1955 PITTWATER ROAD, BAYVIEW

S4.55 AMENDED PLANS

DRAWING LIST

Drawing Title
 Section AA

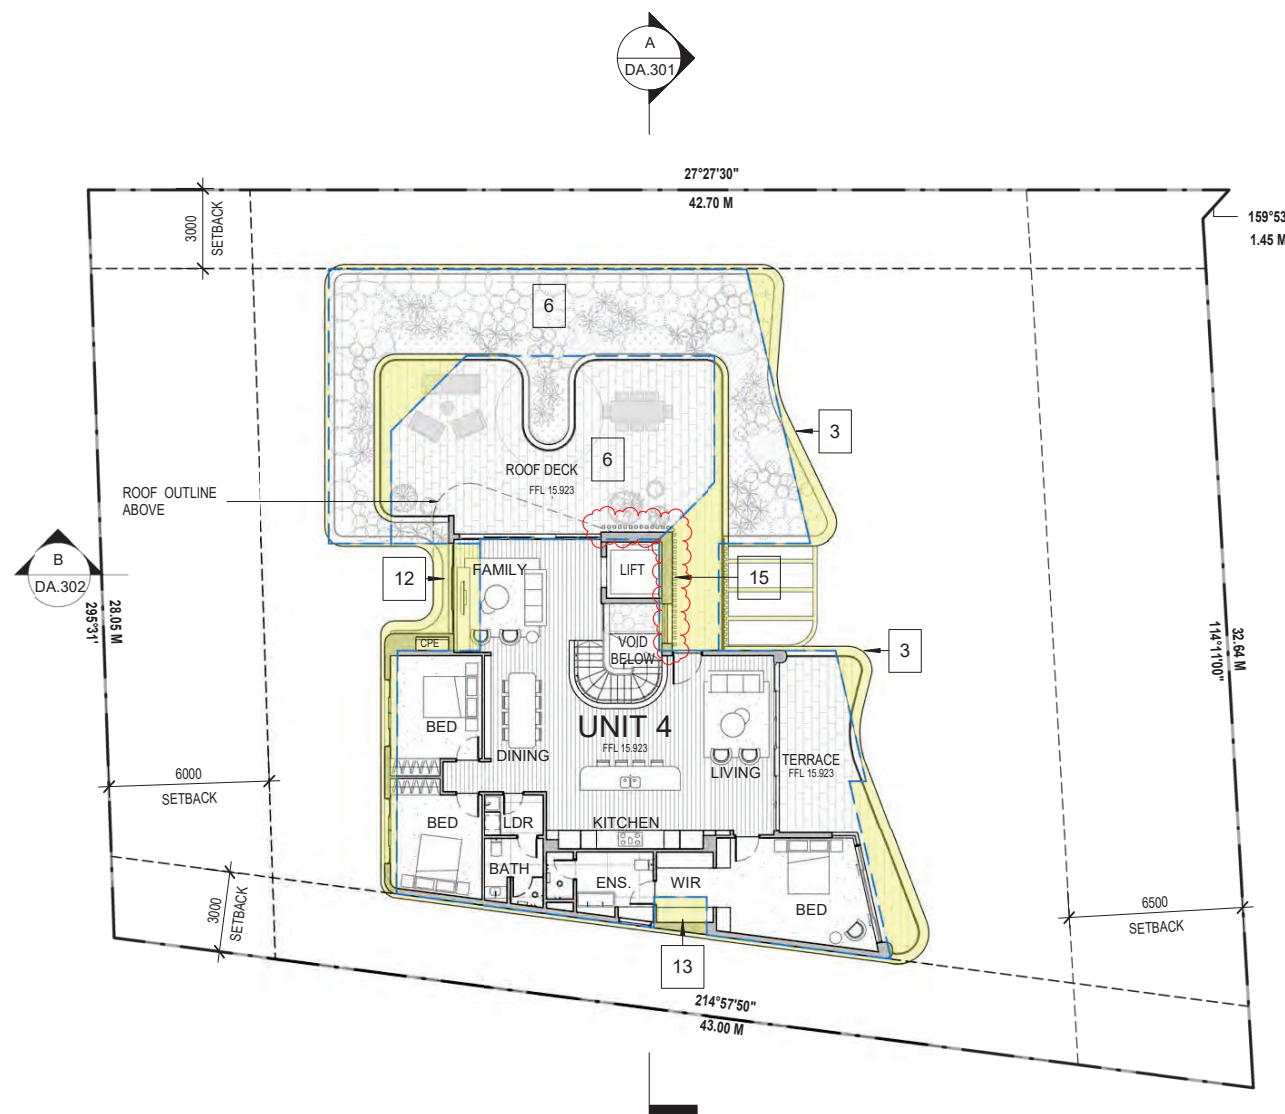
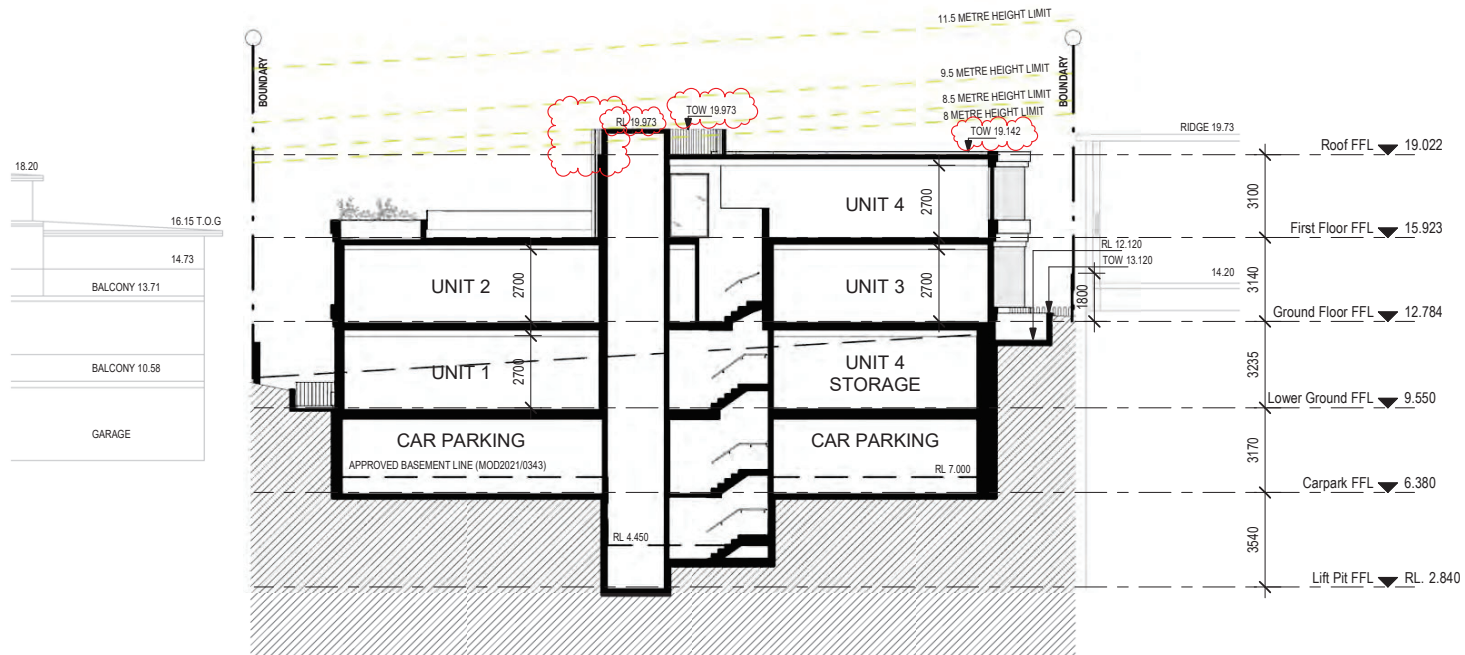
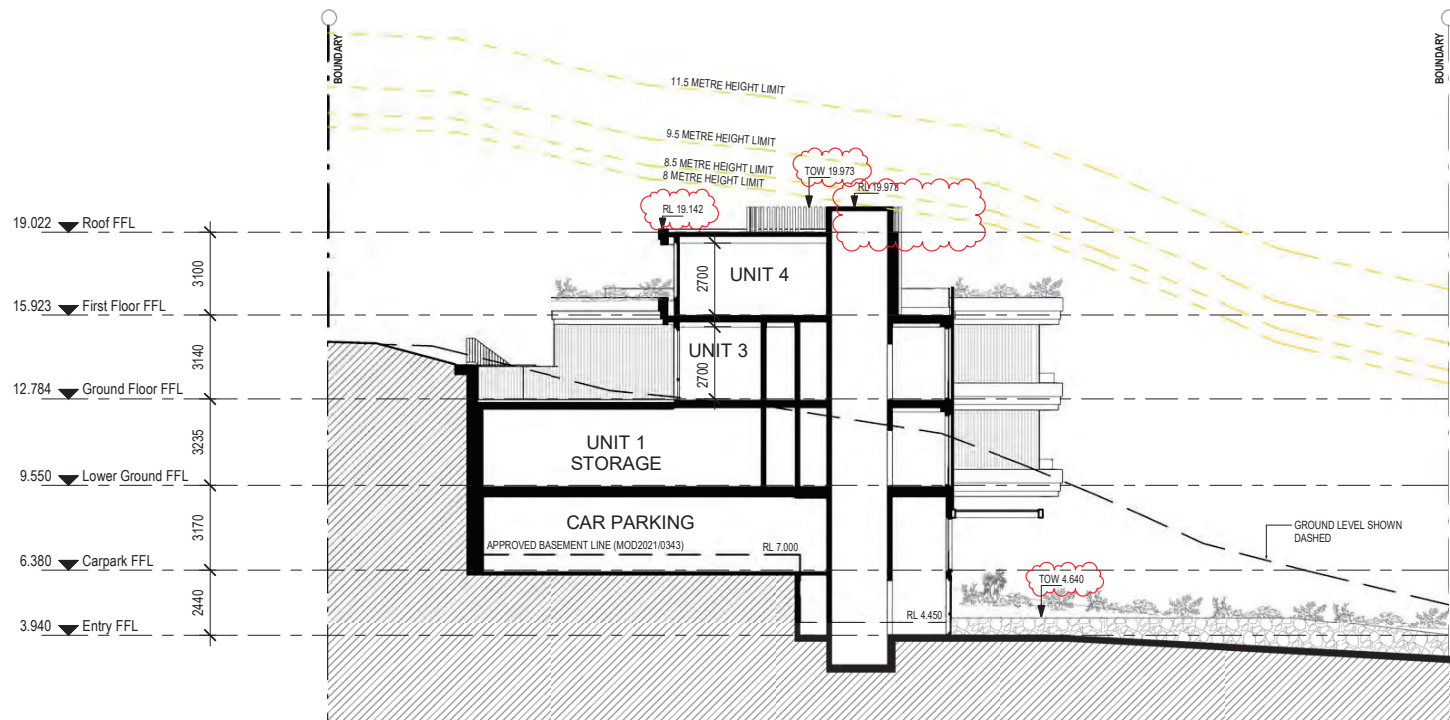
- 1. Entry Pedestrian Ramp** - Increased pedestrian ramp width to 1600mm for accessibility
- 2. Building Entry** - New awning and vertical louvre screen to increase sense of entry.

- 3. Balcony Articulation** - New curved balconies for improved aesthetics. Increase in outdoor private open space area and solar access for improved amenity

- 4. Fencing** - New fencing to provide safety and security
- 5. Roof** - New rooftop plant enclosure to comply with services requirements
- 6. First Floor Roof Deck/ Landscaping** - Change in configuration of First Floor roof deck to integrate with overall building aesthetics. New landscape buffer around perimeter of First Floor roof deck for improved privacy and softening of built form

- 7. Roof & Floor RL** - Adjustment in floor-to-floor heights to reflect structural and building services requirements.
- 8. Vehicular Access** - Design development to comply with accessibility & Australian Standards.

- 9. FRNSW Requirement** - to provide handstand & fire hydrant booster assembly, requiring removal of tree T3 (Refer to Arborist Report).
- 10. Carpark Floor Plan** - Parking re-configuration within approved footprint.

- 11. Lower Ground Floor Plan** - Increase in Unit 4 storage area to accentuate recess and alignment between the two modulated built forms. Louvred door and panels for maintenance and ventilation. New landscaped terrace to integrate with cascading balconies above and overall building aesthetics.

- 12. Unit layouts** - Internal reconfiguration and increase in unit size for improved amenity.
- 13. Elevations** - Removal of wall break in east elevation of Units 3 and 4. Revised façade and window treatments associated with plan amendments

- 14. Boundary Fence** - 1.8m high painted fencing capped and lapped in Dulux 'Winter Fog'
- 15. Vertical Screening** - Continuation of vertical screening over lift shaft to accentuate recess between the two modulated built forms

- 16. Proposed Terrace Extension**

Drawing Title
North Elevation

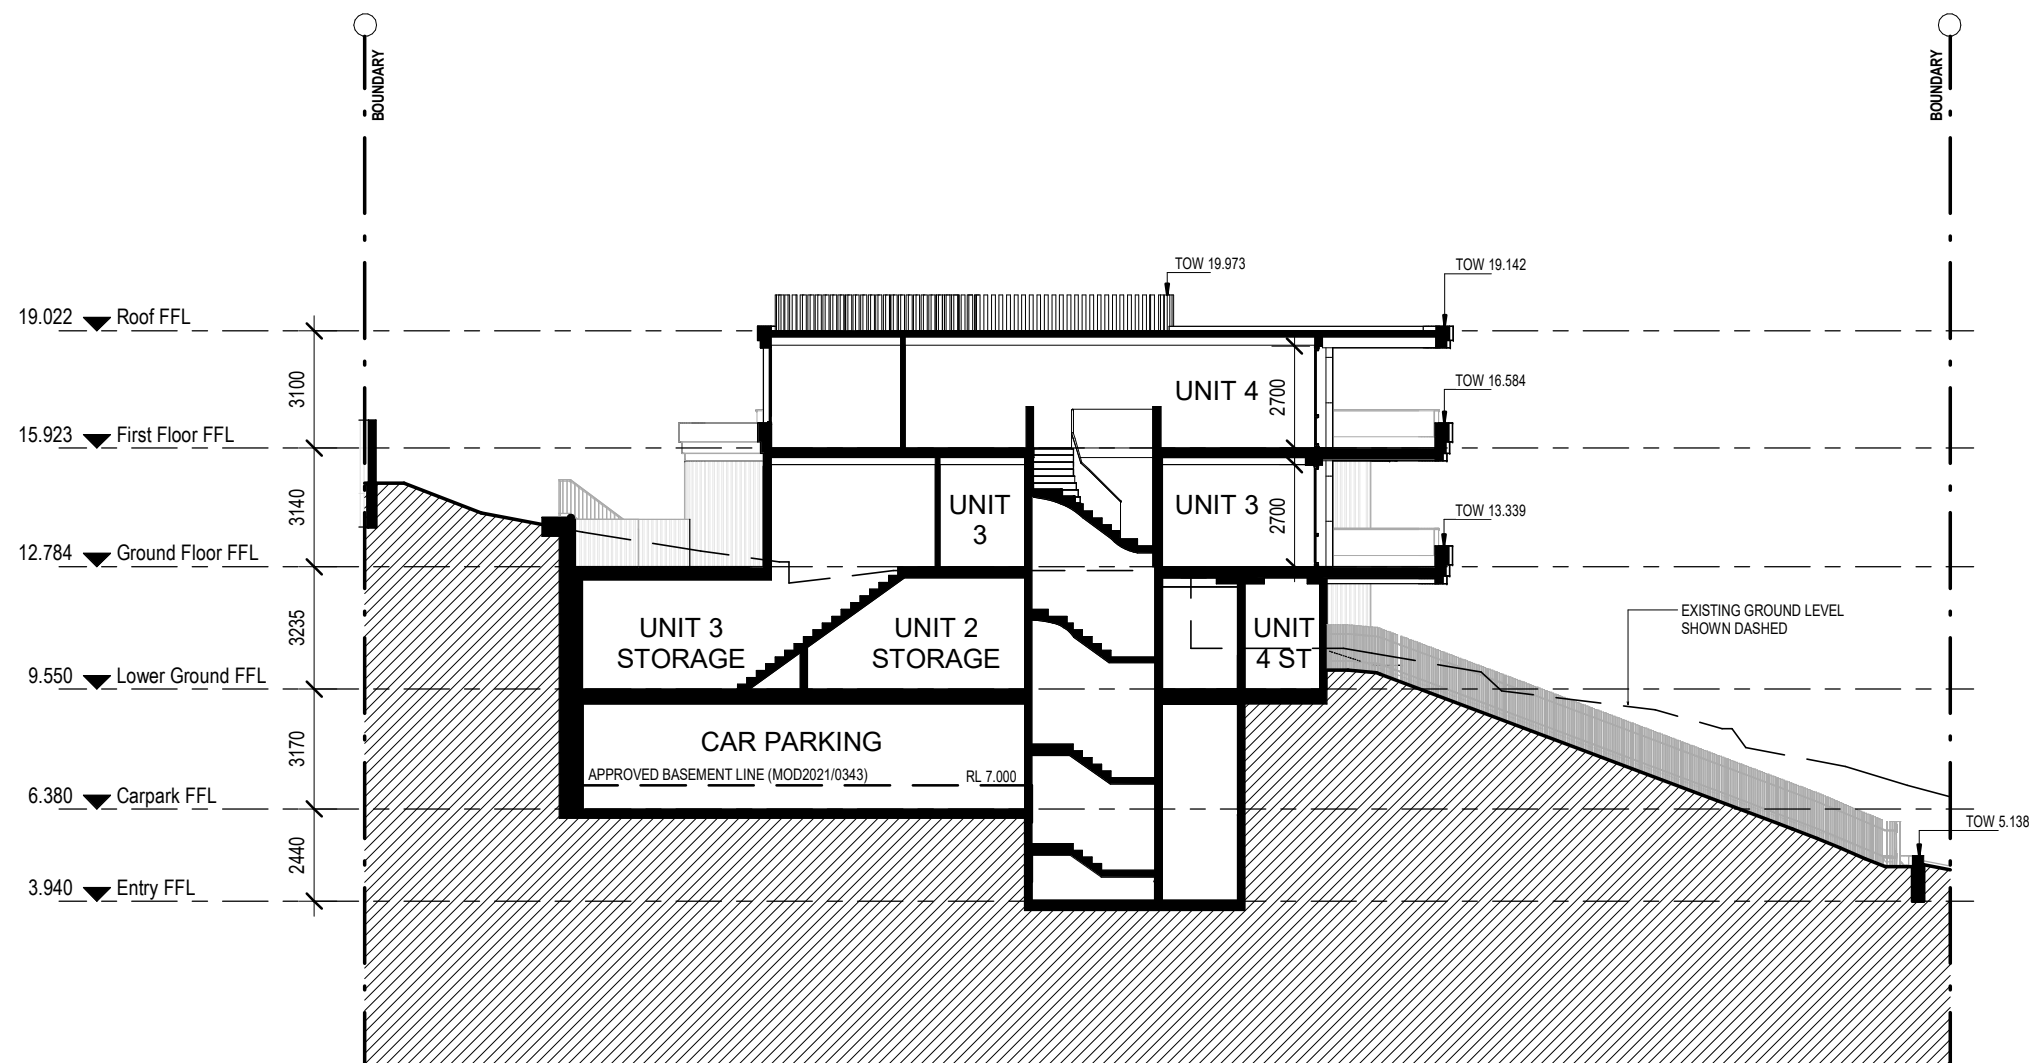
Fire Hydrant Booster Assembly
(to future supplier details)

Booster assemblies are manufactured to conform to the requirement of AS2419 & to relevant local authorities. All components comply to the requirements of AS2419. Any fabricated components are Hot Dipped Galvanised as required in AS2419. Backflow prevention devices can be supplied and designed into assemblies. Backflow devices comply to AS2845.1. All components will withstand pressure testing up to 2100kpa. (Note: Fire Brigade test pressure is 1700kpa.) All booster units can be supplied as individual components or fully part assembled.

- 1. Entry Pedestrian Ramp** - Increased pedestrian ramp width to 1600mm for accessibility
- 2. Building Entry** - New awning and vertical louvre screen to increase sense of entry.

- 3. Balcony Articulation** - New curved balconies for improved aesthetics. Increase in outdoor private open space area and solar access for improved amenity

- 4. Fencing** - New fencing to provide safety and security
- 5. Roof** - New rooftop plant enclosure to comply with services requirements
- 6. First Floor Roof Deck/ Landscaping** - Change in configuration of First Floor roof deck to integrate with overall building aesthetics. New landscape buffer around perimeter of First Floor roof deck for improved privacy and softening of built form

- 7. Roof & Floor RL** - Adjustment in floor-to-floor heights to reflect structural and building services requirements.
- 8. Vehicular Access** - Design development to comply with accessibility & Australian Standards.

- 9. FRNSW Requirement** - to provide handstand & fire hydrant booster assembly, requiring removal of tree T3 (Refer to Arborist Report).
- 10. Carpark Floor Plan** - Parking re-configuration within approved footprint.

- 11. Lower Ground Floor Plan** - Increase in Unit 4 storage area to accentuate recess and alignment between the two modulated built forms. Louvred door and panels for maintenance and ventilation. New landscaped terrace to integrate with cascading balconies above and overall building aesthetics.

- 12. Unit layouts** - Internal reconfiguration and increase in unit size for improved amenity.
- 13. Elevations** - Removal of wall break in east elevation of Units 3 and 4. Revised façade and window treatments associated with plan amendments

- 14. Boundary Fence** - 1.8m high painted fencing capped and lapped in Dulux 'Winter Fog'
- 15. Vertical Screening** - Continuation of vertical screening over lift shaft to accentuate recess between the two modulated built forms

- 16. Proposed Terrace Extension**

Drawing Title
 First Floor Comparison Plan

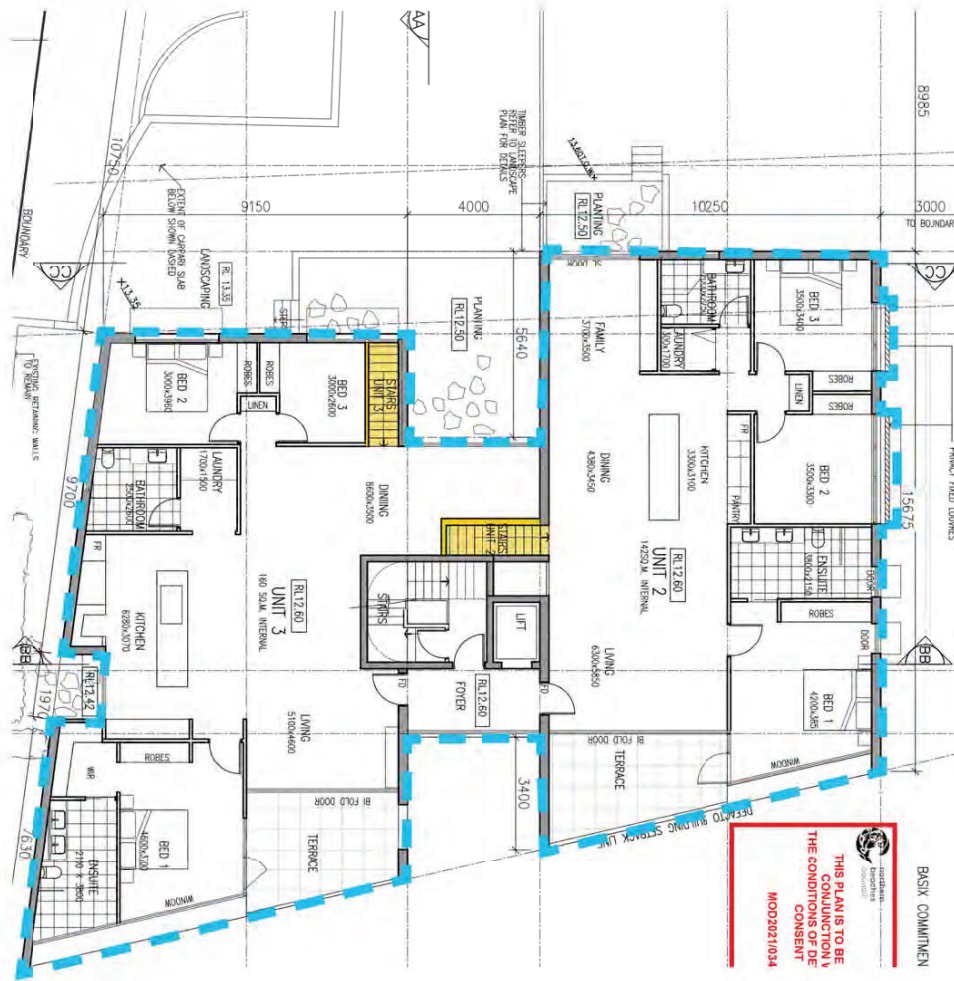
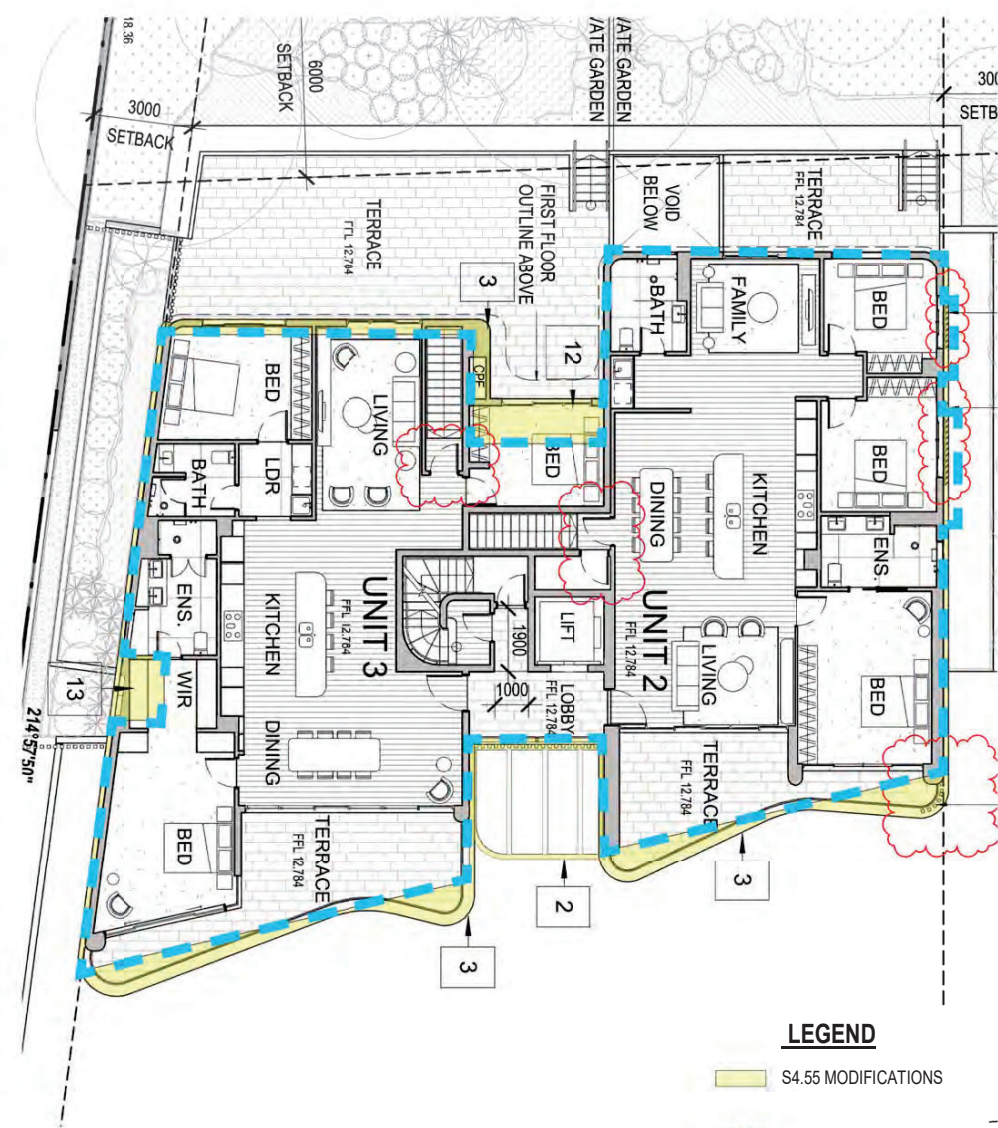
**HARPO STAND AND
FIRE HYDRANT
BOOSTER ASSEN**

**DENSE TREE AND
SHRUB PLANTING
OBSCURING SITE
AS VIEWED FROM
PUBLIC DOMAIN**
©2005/06/06

SOUTH ELEVATION

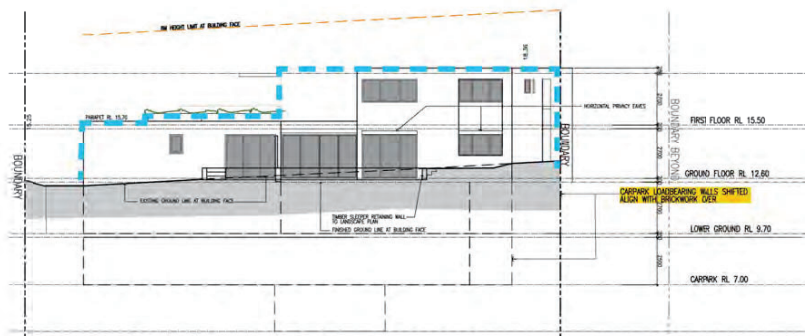
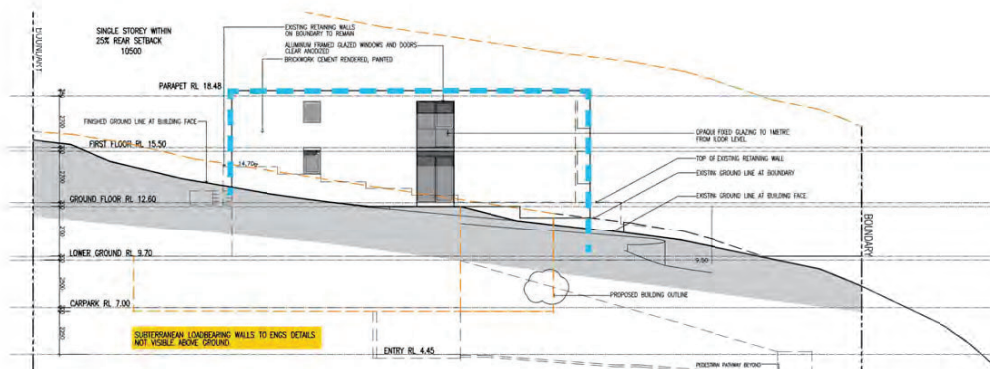
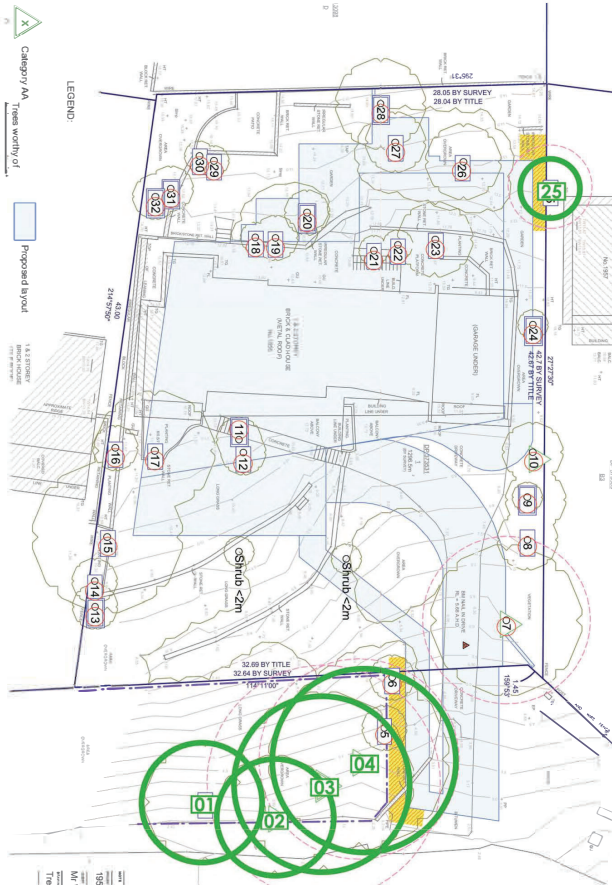
--- APPROVED BUILDING OUTLINE MOD 2021/0101
0 2m 4m 10m
SCALE 1:300 @ A3
